**Request for Bids for the South Cap Closure  
Phase II Construction at the Franklin County Sanitary Landfill**

This Addendum No. 3 shall be considered part of the RFB for the South Cap Closure Phase II Construction at the Franklin County Sanitary Landfill and is intended to correct, change, and/or add to the documents as described below. Please make sure to complete the Addenda Acknowledgement form included in the *Required Documents*.

# PHASE II SOUTH CAP CLOSURE CONSTRUCTION

# FRANKLIN COUNTY SANITARY LANDFILL

**5**  
**8** FINAL COVER SYSTEM TERMINATION IN "LOBE" AREA  
NOT TO SCALE

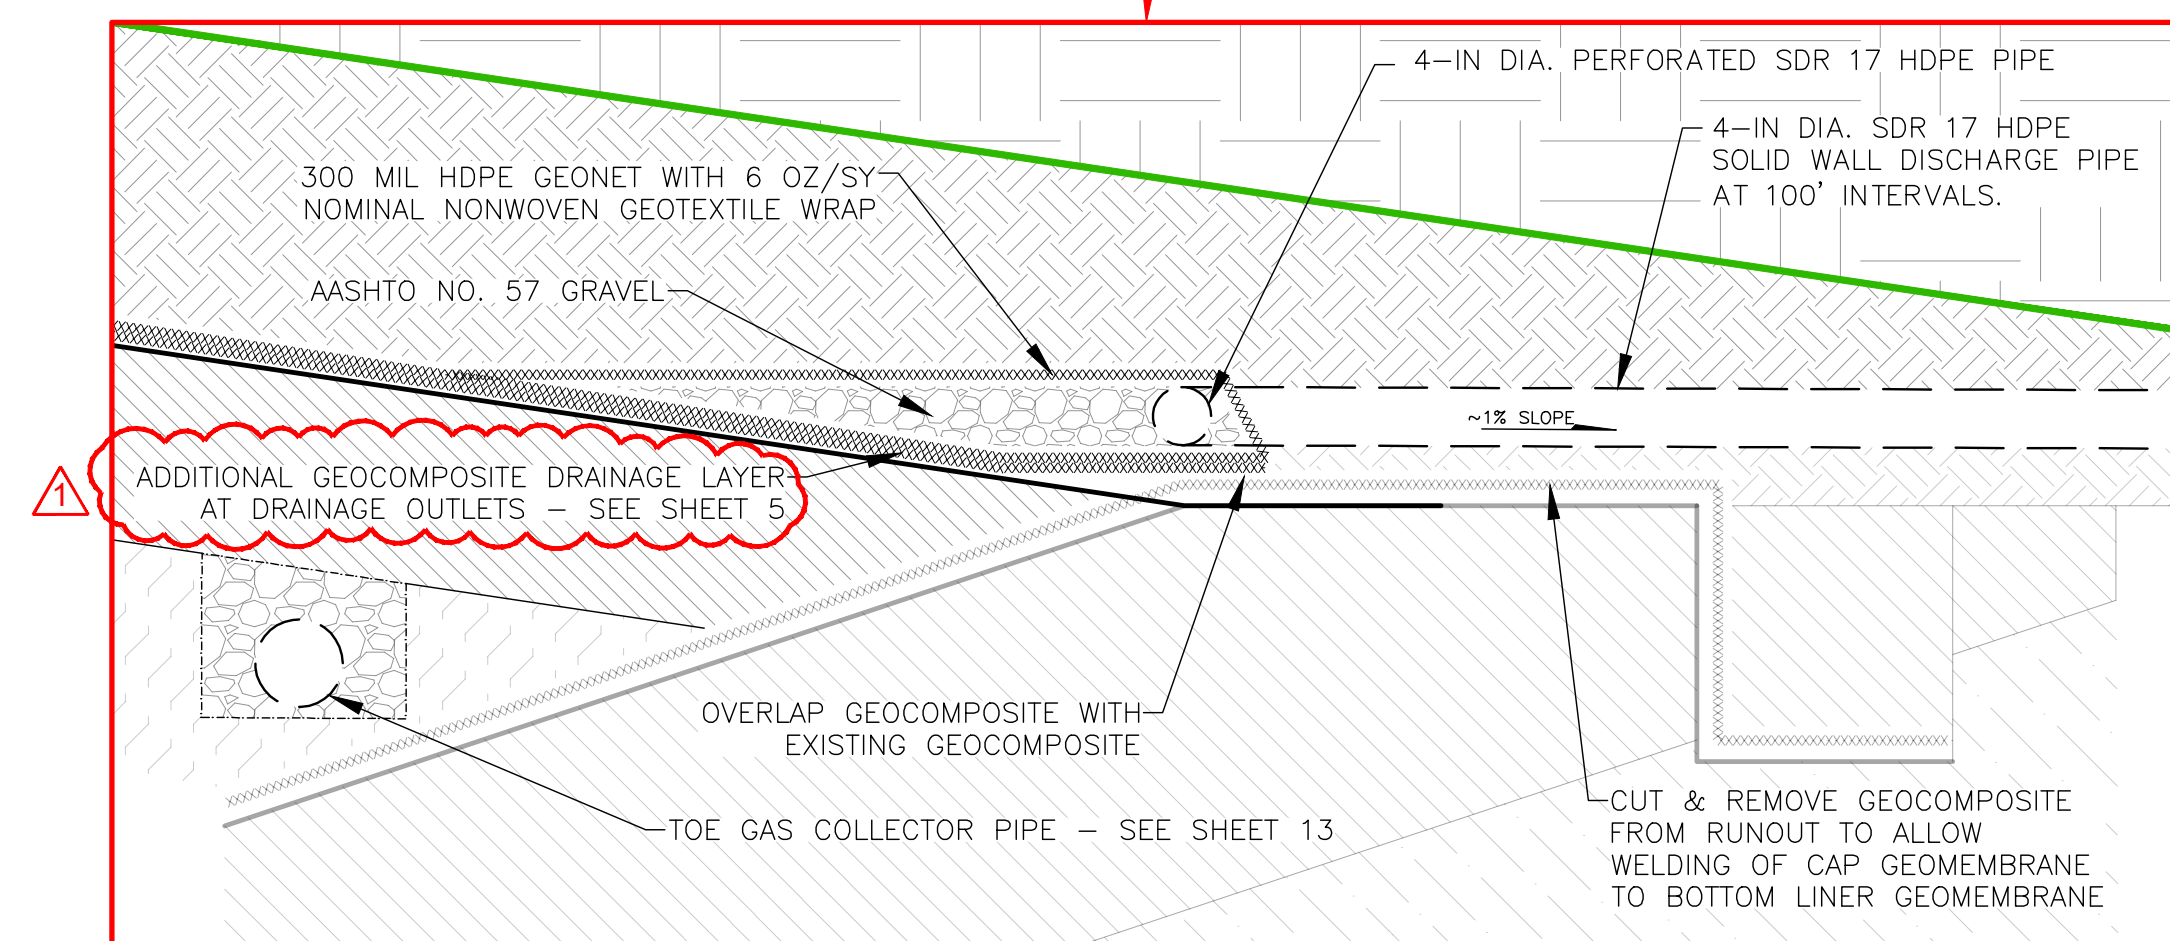
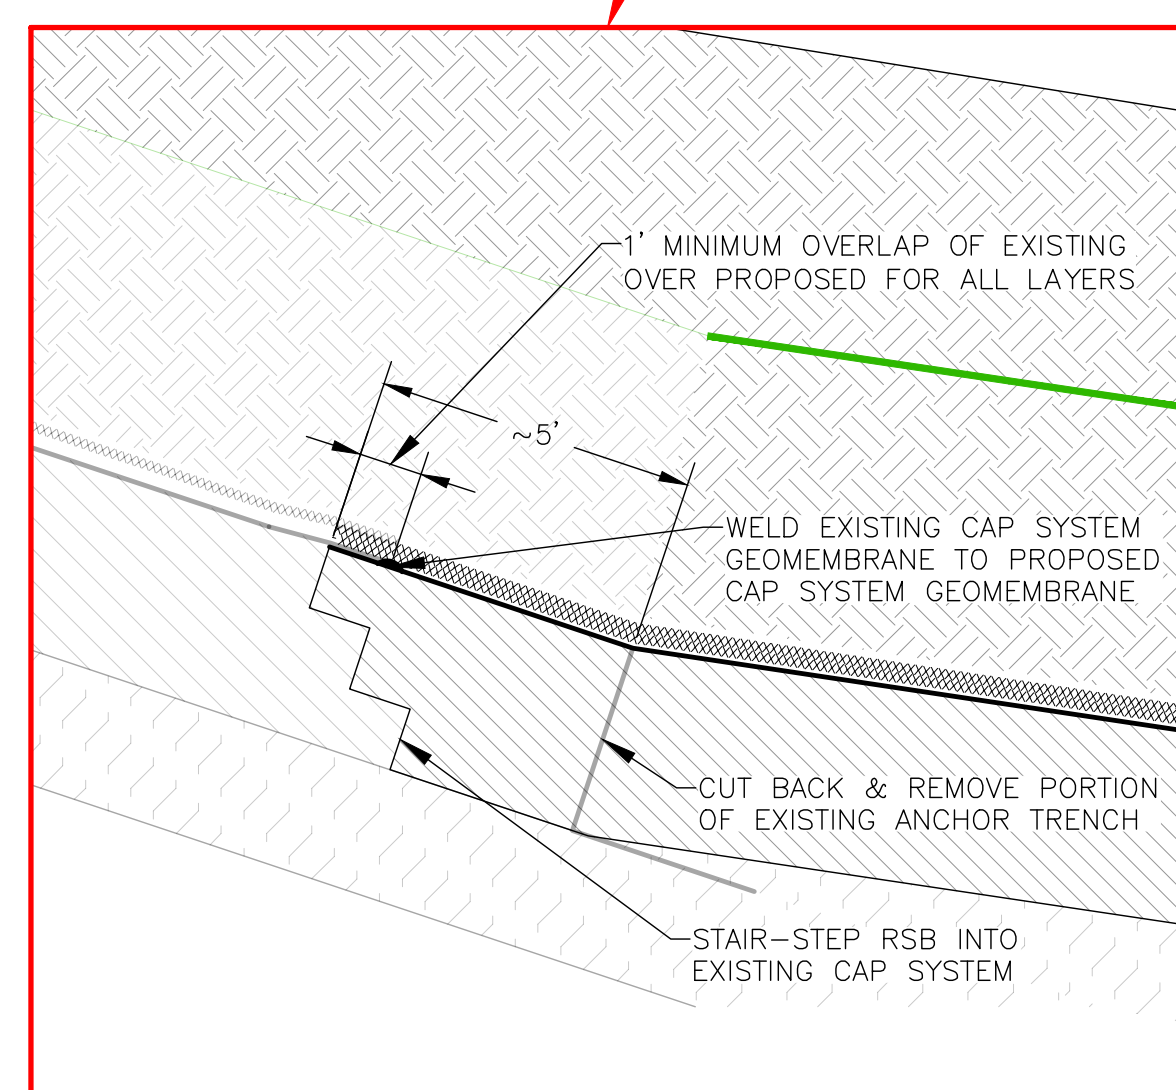
Question #4: *Sheet 5 shows additional composite... I do not see this in the details. Can you provide more information?*

| NO. | DATE       | REVISION DESCRIPTION                 |
|-----|------------|--------------------------------------|
| 1   | 04/13/2026 | ADDED LOCATION OF EXTRA GEOCOMPOSITE |

**Answer:** Sheet 8 (attached) has been updated slightly to reflect the additional layer of geocomposite. The quantity of additional geocomposite was included in Bid Item 14.
